ADDENDUM | No. 1

PROJECT	Minnehaha Community Water Corp. – Highway 137 Water Utility Relocation		
BID DATE	10:00 AM	CDT	October 20, 2017
BID LOCATION	Minnehaha Community Water Corporation 47381 248 th Street, Dell Rapids, SD 57022		
ISSUE DATE	October 16, 2017		
NOTICE	Failure to acknowledge all addenda in the BID may cause rejection of the BID. See Instructions to Bidders.

Drawing Sheet 8

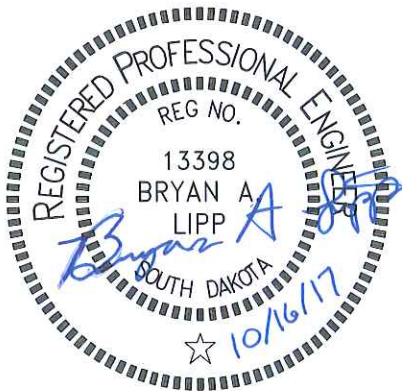
Location "D",

Change: Gate valve shall be MJ Gate Valve & Box w/ Joint Restraints. Fire Hydrant shall be MJ Fire Hydrant w/ Joint Restraints & Block (6.5' bury depth).
